**City of Ketchum
Planning & Building**

IN RE:)
)
140 West 2nd) KETCHUM PLANNING AND ZONING COMMISSION
Design Review) FINDINGS OF FACT, CONCLUSIONS OF LAW, AND
Application File Number: P24-092) DECISION
)
)
Date: March 12, 2024)

PROJECT: 140 West 2nd

APPLICATION TYPE: Design Review

EAST (PROPERTY LINE) ELEVATION

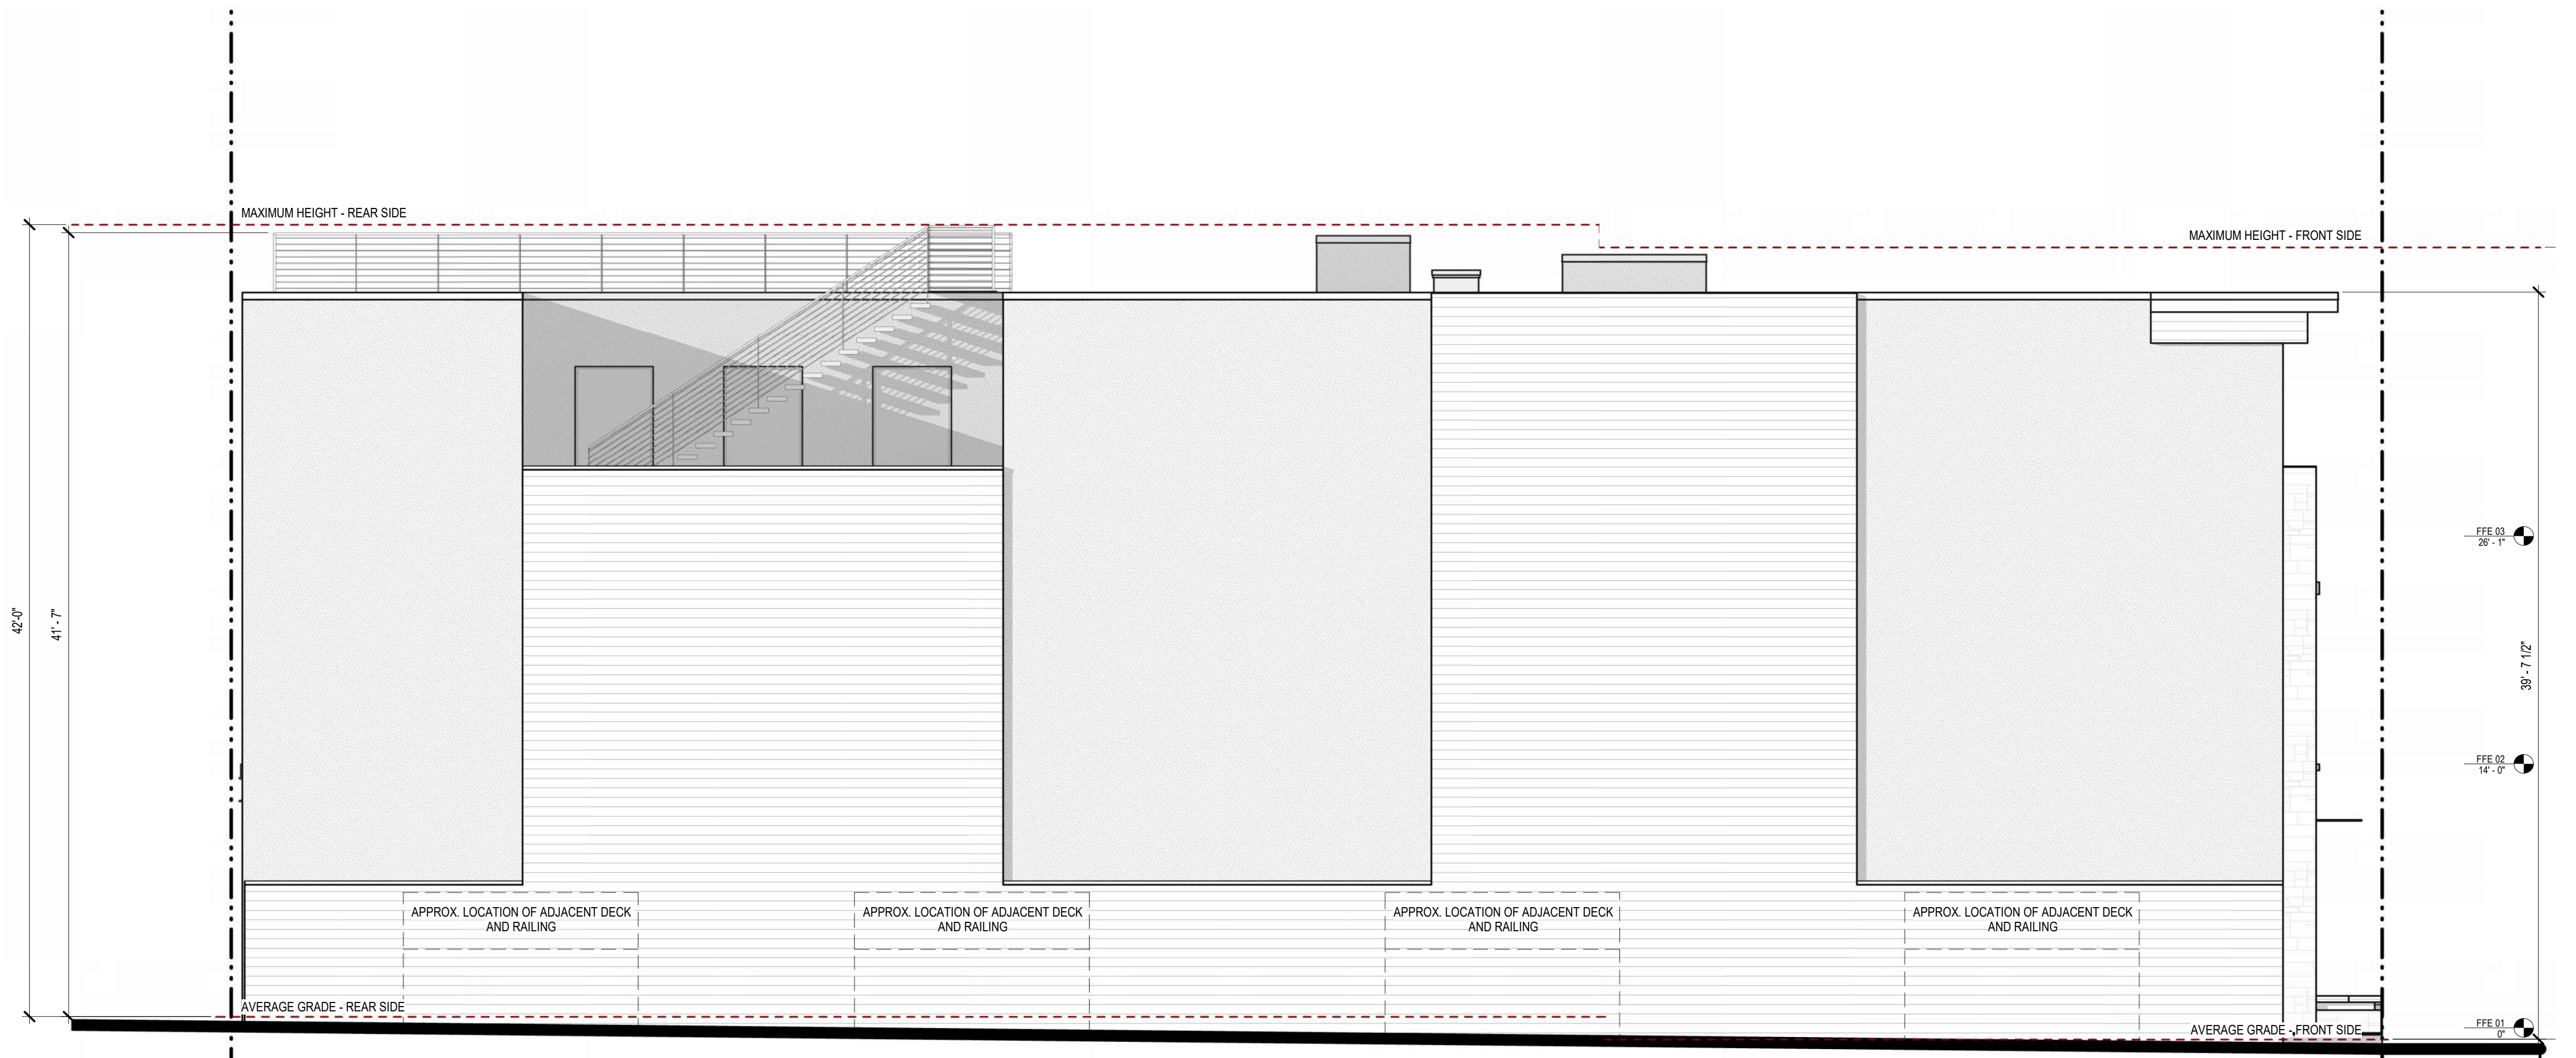
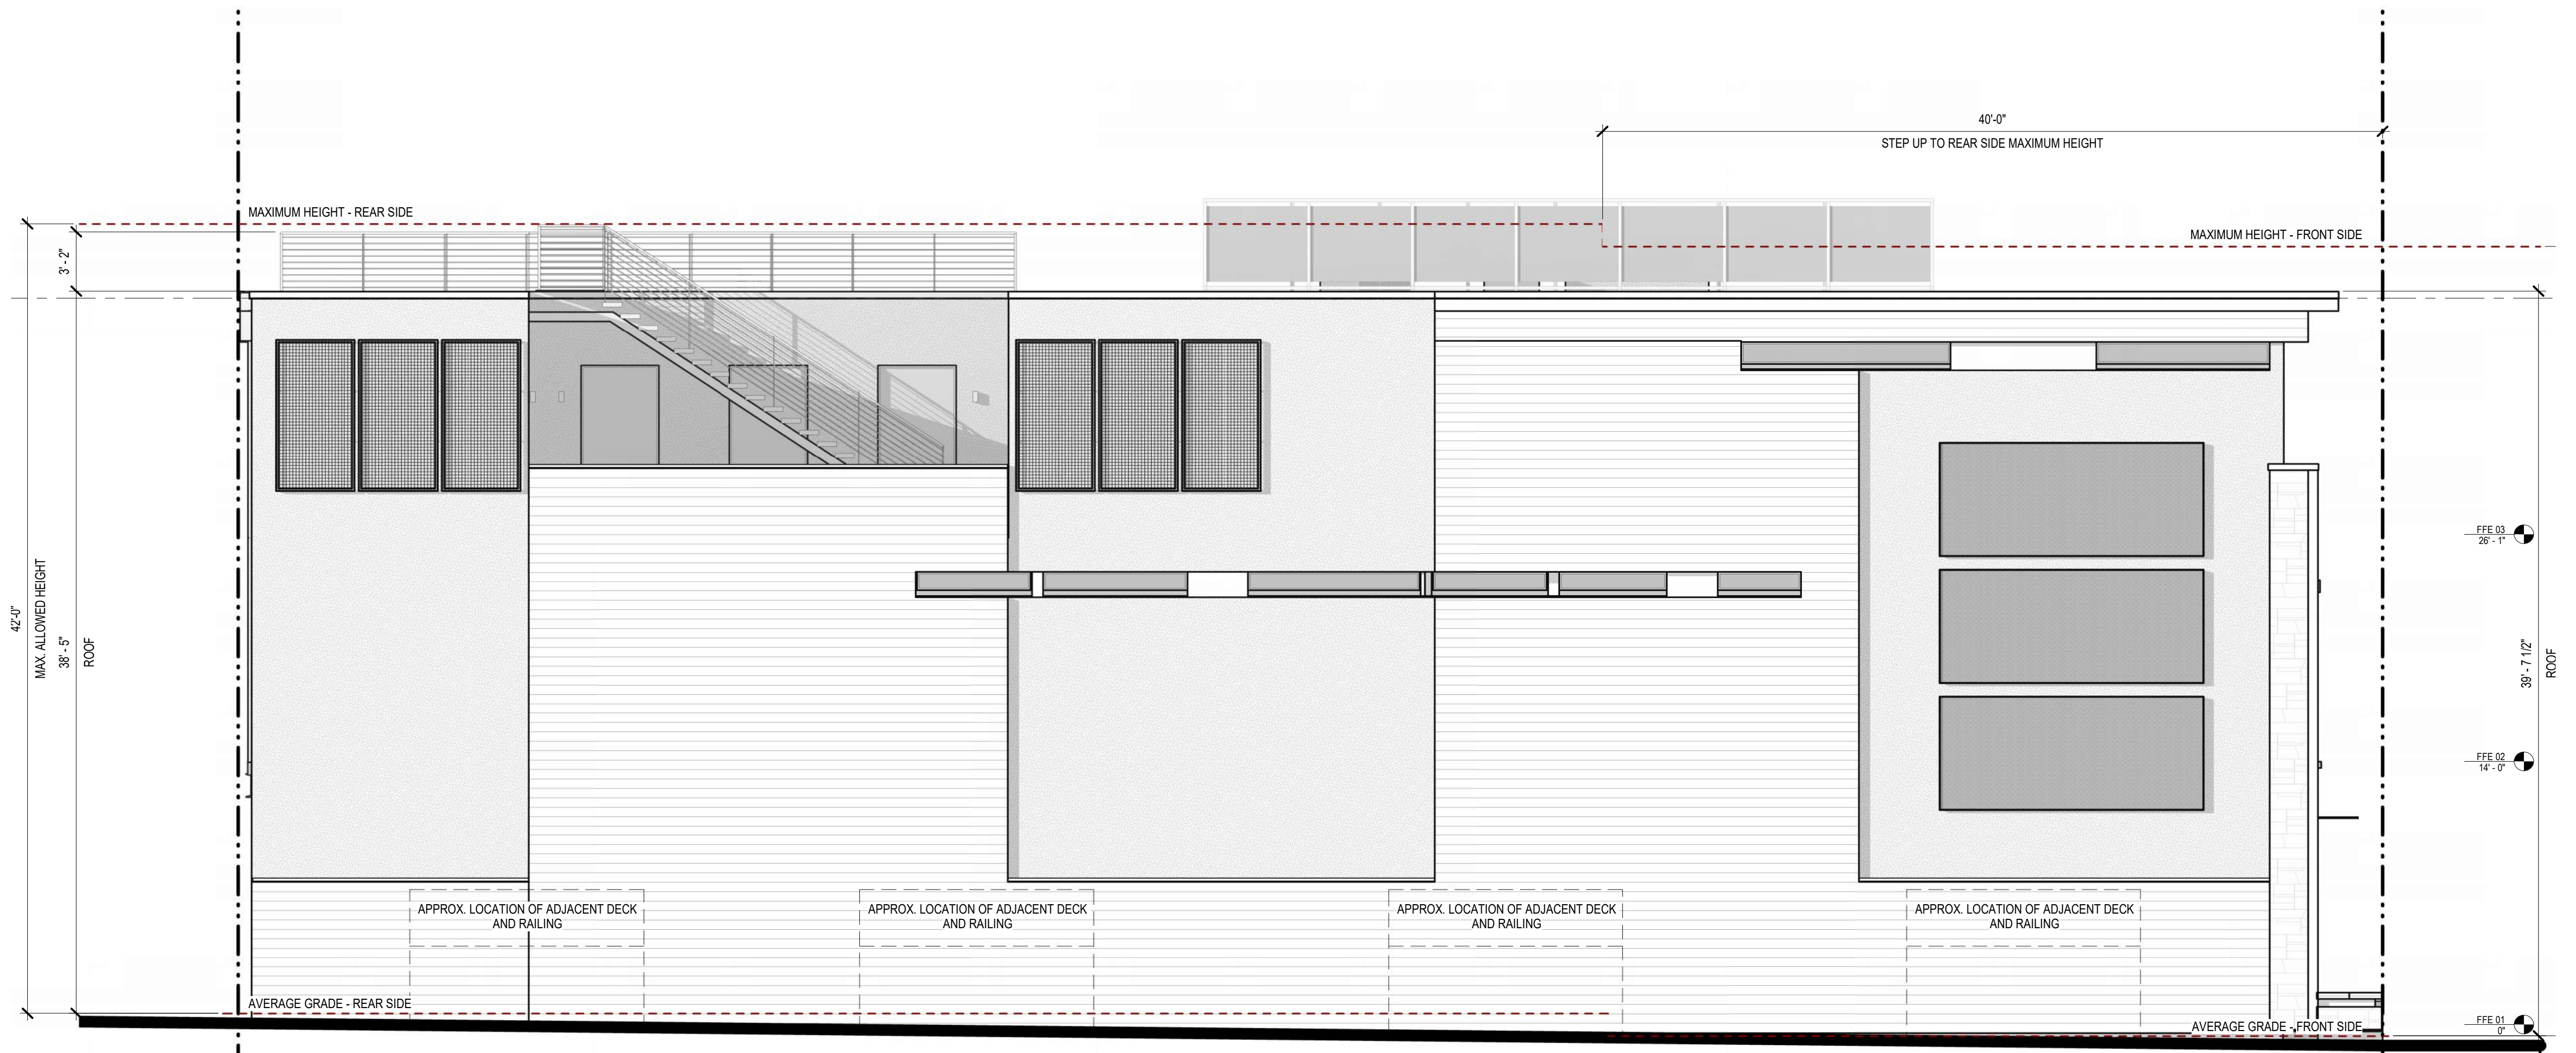
East Wall Comments from 11/12/2024 Pre-Application Hearing:

- Come back with more careful thought to animate east wall.
- Consider addition of horizontal windows or translucent panels.
- Interior lot lines are difficult.
- Be as creative as possible to break up wall.
- Consider extending roof fascia to wood siding.
- Third floor terrace erosion and planter are good things.
- Trees go a long way to soften wall.
- Hope for successful agreement to resolve courtyard.

Proposed Revisions to East Wall:

- Added steel lattice on either side of the third-floor deck to facilitate plant coverage and greenery facing the Galena Building.
- Added decorative metal panels at the corner of Second Street to add visual interest and texture to elevation.
- Extended the Second Street roof detail farther inboard to extend nearly half of the length of the building, carrying the front elevation motif around the corner and unifying the front and side elevations.
- Added deeply recessed horizontal clerestory windows on the second and third floor to add visual interest and texture to the elevation.

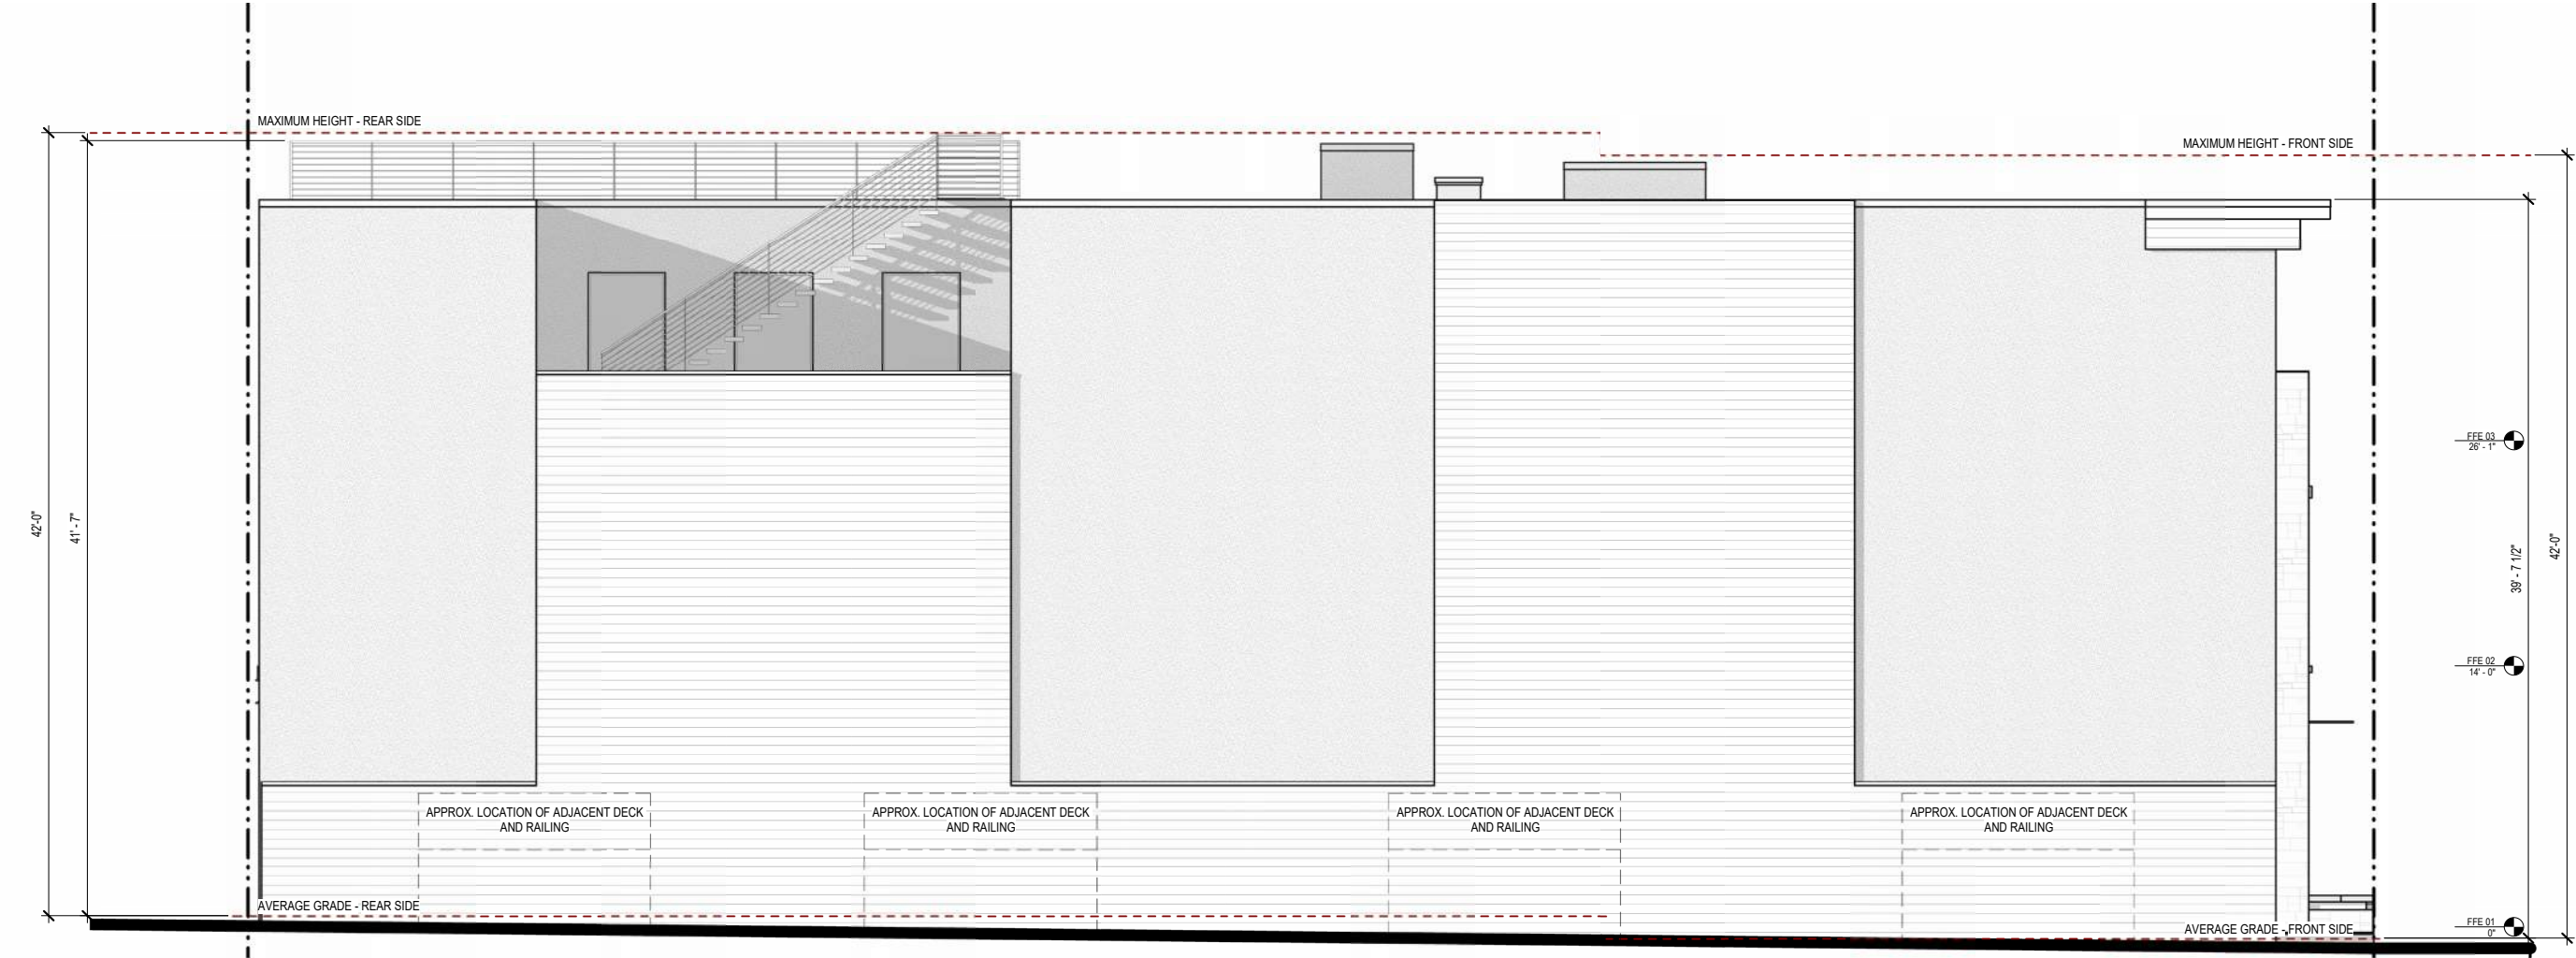
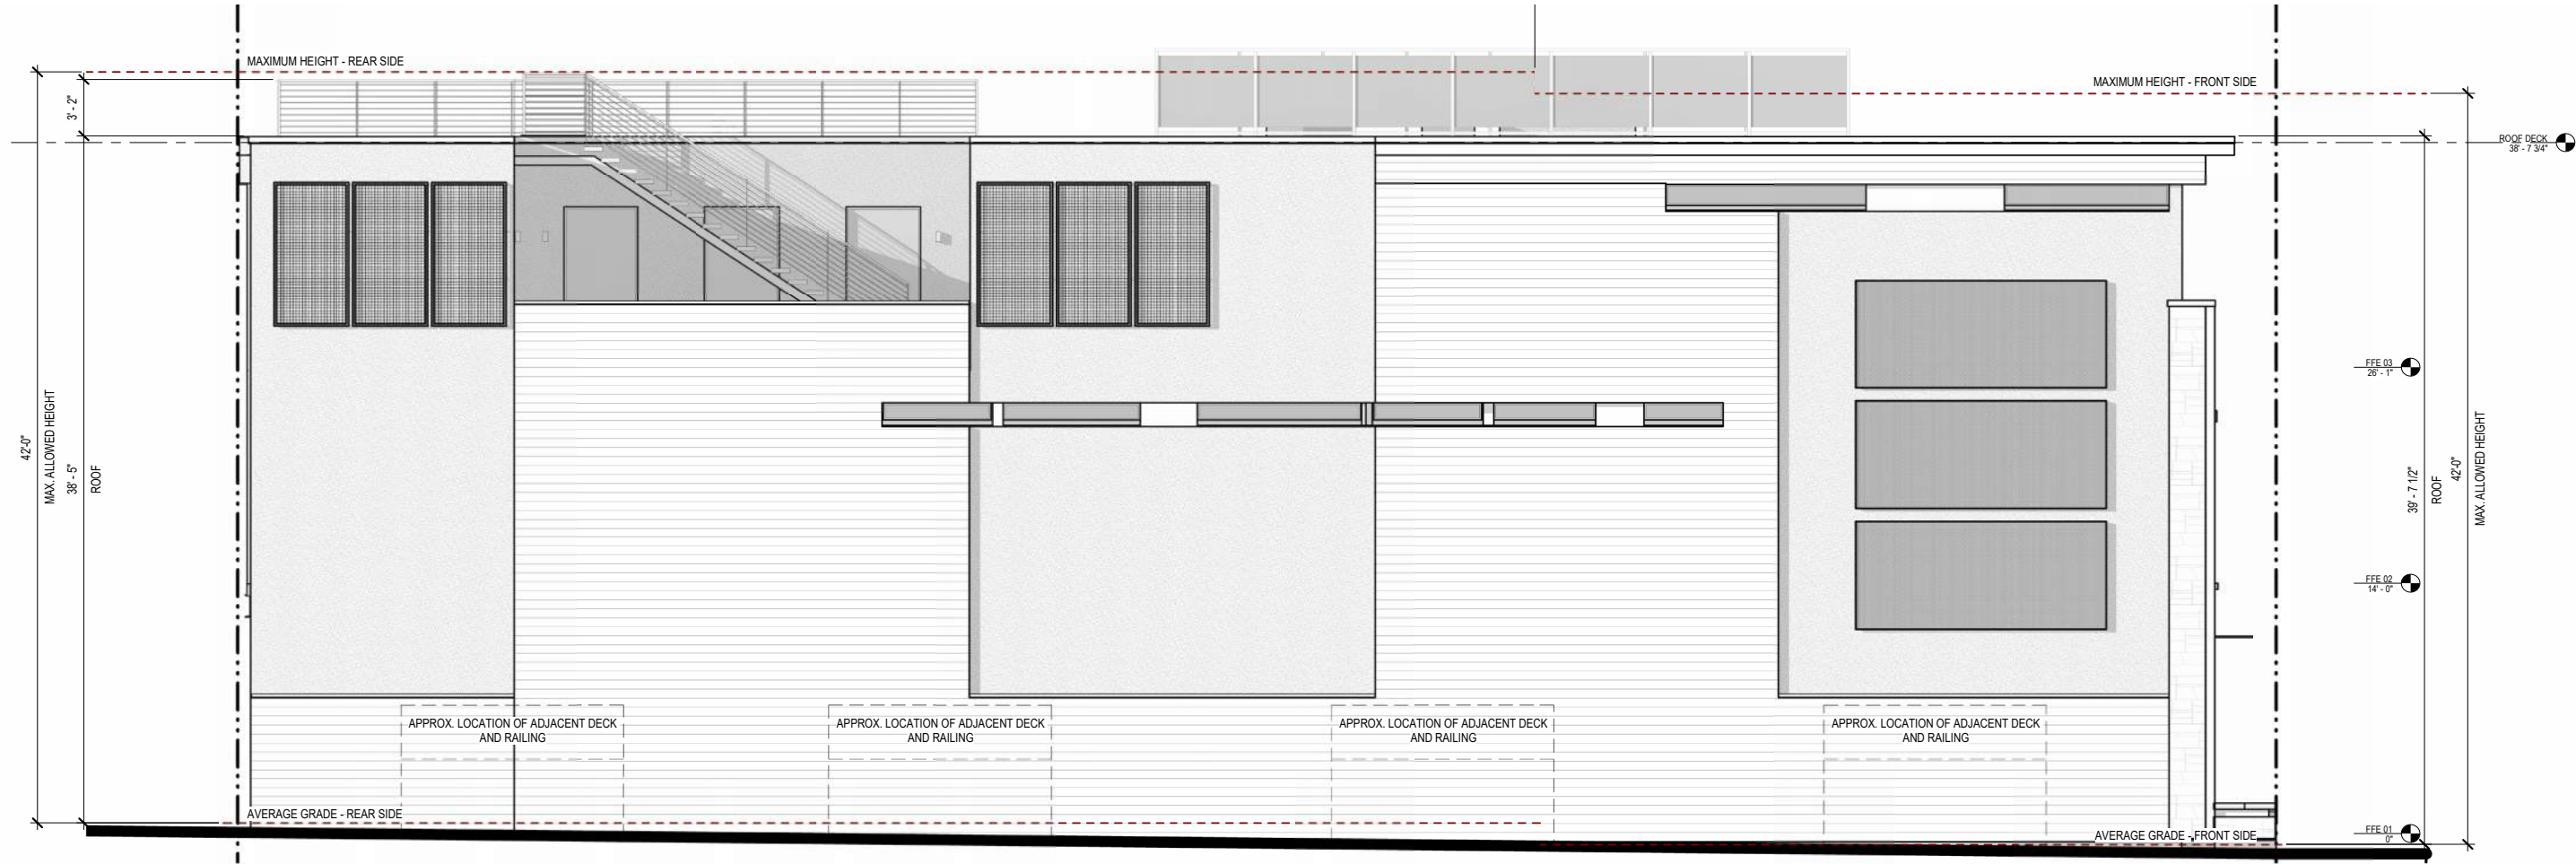
PREVIOUS DESIGN

PROPOSED DESIGN
